September 10, 2019
ET 19-0019

Subject: Docket No. 50-482: Response to Request for Additional Information "Revision to Technical Specification 3.3.5, Loss of Power (LOP) Diesel Generator (DG) Start Instrumentation"

Attachment I to ET 19-0019
Response to Request for Additional Information "Revision to Technical Specification 3.3.5, Loss
of Power (LOP) Diesel Generator (DG) Start Instrumentation"
(12 Pages)

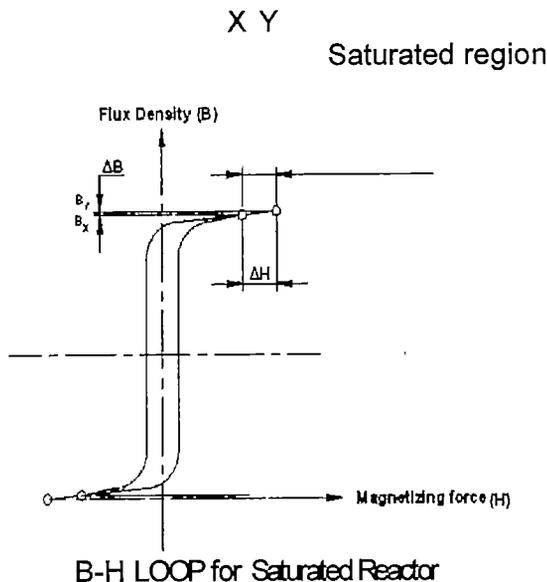
According to the WCGS, Updated Final Safety Analysis Report (UFSAR) Figure 8.3-6-01, "DC Main Single Line Diagram," the NN inverters are normally fed from Class 1E 125 VDC buses. However, if an inverter is inoperable, then based on TS 3.8.7, the associated vital bus can be fed from a regulating transformer, up to a Completion Time of 24 hours. Please describe the voltage regulating feature of regulating transformer, and whether this feature was modelled in the load flow analysis. If not modelled, please explain whether the voltage regulating feature of regulating transformer could alleviate the low voltage conditions at the above inverter buses.

The NN Inverters are ferroresonant transformer-based voltage regulating device intended for use in uninterruptible power systems (UPS) or in stand-alone applications (Reference 1). It is a transformer-based power supply that uses nonlinear magnetic properties and a resonant circuit to provide a stable output voltage over a wide range of input voltage and load current variations.

The principle of ferroresonance is used to drive the transformer core in saturation that regulates wide range of unregulated input voltages and convert them to a well regulated stable desired output voltage at the loads.

- Refer to a typical B-H loop (see below), specifically the region used to achieve the transformer reactor saturation design for the application of CVT. When the transformer is saturated to regulate the desired voltage, the flux density B is constant ($\Delta B = 0$, independent of input voltage) and the voltage across the transformer (treated as reactor) becomes constant (voltage output = $4.44BN\omega A f$, where N is number of turns, A is area of cross section, f is the operating frequency, are constant) irrespective of the input voltage. For a highly saturated region (between X and Y), the output voltage remains constant for input voltages. Consider the input voltage range from 90% to 110% of 480 V (the voltage range the CVT is tested). Now consider the input voltage is at 89% of the 480 V and assuming that the saturation region of magnetic B-H curve is no longer in the highly saturated region ($\Delta B \neq 0$, but still in the neighborhood of the knee of saturation), it is argued that the flux density is still relatively near the saturation region and will not abruptly pulled in the linear region of the B-H curve. This reasoning is based on the review of test data (Reference 2) where it is shown that the CVT performs in the highly saturated region in the in the input voltage range of 90% to 110% of 480 V. This can be seen on the characteristics of B-H curve, the region of B-H just to the left of X shown on the B-H curve. For all practical purposes, the change in the output voltage at 89% of 480 V can be argued to much less than 1% due to the non-linear characteristic of the B-H curve near that region. Therefore, for a drop of less than 1% input

Typical ETAP dynamic modeling parameters illustrated as below.

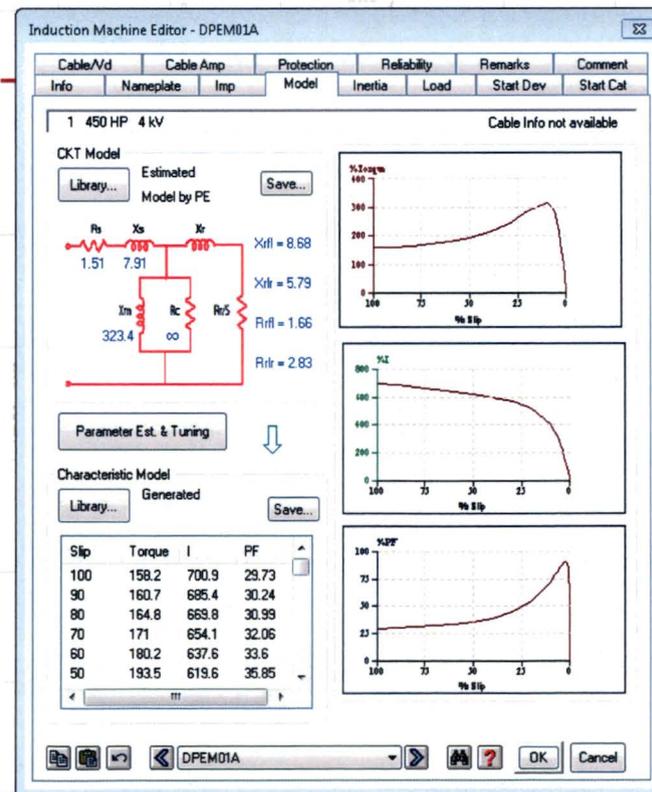
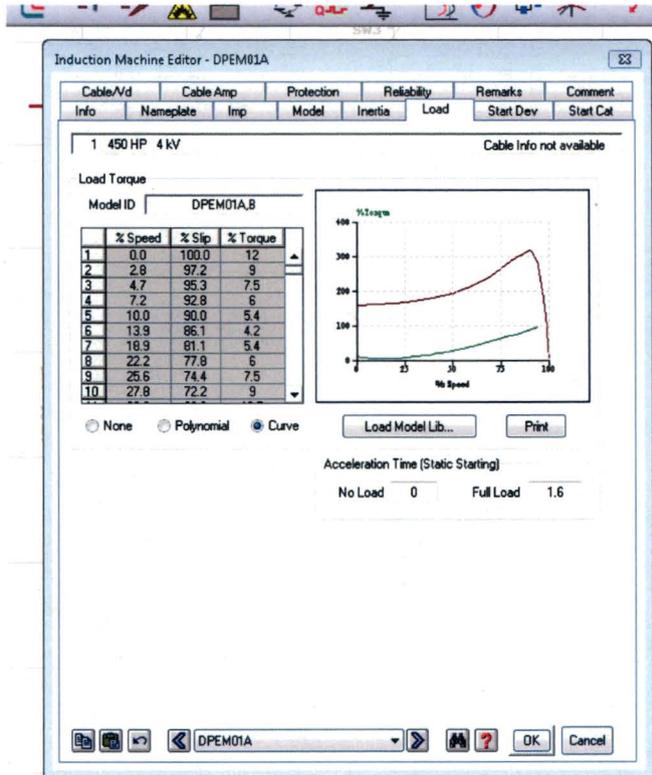
Please confirm whether the licensee performed dynamic simulation for all motors or only for certain specific motors, considering that detailed motor data for dynamic simulation is typically not readily available. Please provide a list of motors for which dynamic simulation was performed, and a brief description of the dynamic motor modelling/simulation.

An ETAP Transient Stability Analysis, which includes a Dynamic Motor Acceleration analysis, was performed as part of the enhanced overcurrent evaluation that was performed to verify the adequacy of the DV Relay Time Delay (with accident signal) for transfer to onsite emergency power. As indicated in the LAR, Attachment I, page 10, an enhanced overcurrent evaluation was performed for 20 TOLs that did not meet the acceptance criteria based on the NEI 15-01 methodology. The NEI 15-01 methodology conservatively assumes the motors continue to draw starting current until the DVR times out (8.5 seconds). The enhanced TOL evaluation determined the motor starting voltage at the LOVR lower analytical limit, which is the lowest degraded voltage that can occur without tripping the LOV relays. If the motor terminal voltage is high enough to start the motor, the resultant motor starting current and acceleration time is then calculated. After the motor reaches rated speed, the running current is determined. Thus, during the concurrent degraded voltage condition and LOCA, the TOL is evaluated for motor starting current only during the acceleration period and for running current for the remainder of the 8.5 second degraded voltage condition. The methodology for performing the enhanced overcurrent evaluation is provided in WCNOG Calculation XX-E-009-001-CN006, Section 4.7.1.3. The dynamic modeling of motors is carried out in XX-E-006 where the dynamic motor parameters are entered using vendor provided performance characteristics.

Attachment II to ET 19-0019
Proposed Technical Specification Changes (Mark-up)
(1 Page)

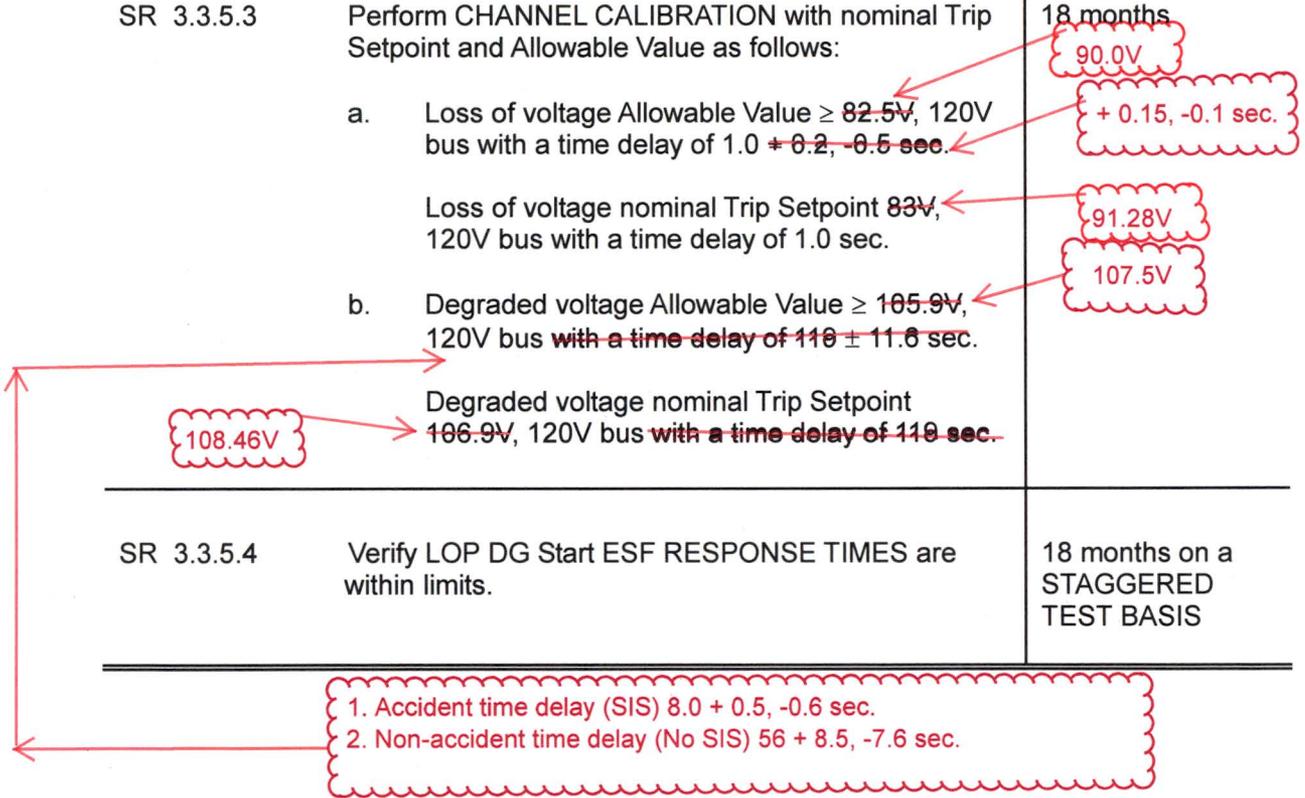
Please provide justification why the proposed change revises the TS to provide only the time delay associated with a SIS present.

Based on further review Wolf Creek has determined that per NUREG-0800 (B.1.b) two separate time delays are required for the TS second level of undervoltage protection. The first-time delay is the 8.0-second "DVR initial time delay" and the second-time delay is the 48.0 second "DVR non-accident time delay setting identified in response #2. Based on this LAR, TS requested TS changes for TS 3.3.5, SR 3.3.5.3b have been revised as follows:

SR 3.3.5.3	Perform CHANNEL CALIBRATION with nominal Trip Setpoint and Allowable Value as follows: a. Loss of voltage Allowable Value $\geq 90.0V$, 120V bus with a time delay of $1.0 + 0.15, -0.1$ sec. Loss of voltage nominal Trip Setpoint $91.28V$, 120V bus with a time delay of 1.0 sec b. Degraded voltage Allowable Value $\geq 107.5V$, 120V bus 1. Accident time delay (SIS) $8.0 + 0.5, -0.6$ sec. 2. Non-accident time delay (No SIS) $56 + 8.5, -7.6$ sec. Degraded voltage nominal Trip Setpoint 108.46 , 120V bus	18 months
------------	---	-----------
